TORIN INC. – VEHICLE LIFT IMPROVEMENTS

DATE: 20221114

PA SKU: 8964850

Torin Item: T9000-4ST

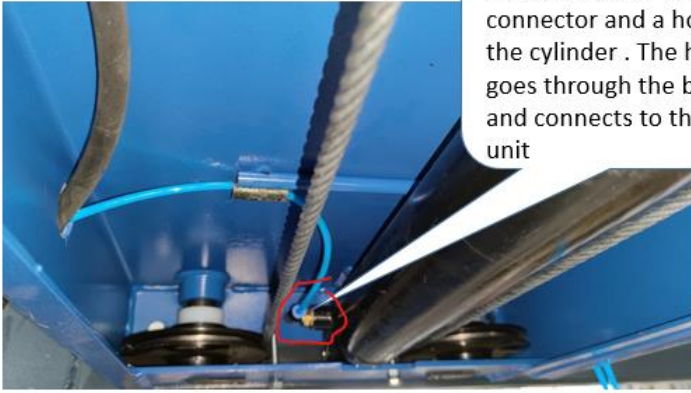
CURRENT	IMPROVEMENT
 There is a muffler at the air bleed hole on the cylinder	Torin improvement to the 4 post lift by adding a hose to prevent the cylinder from corrosion and debris getting into the hydraulic system
	 Add two connectors, one on the cylinder and one on the power unit
	 Remove the muffler at the air bleed hole, add a connector and a hose on the cylinder. The hose goes through the bridges and connects to the power unit
	 The hose goes from the cylinder and connects to the oil return hole on the power unit
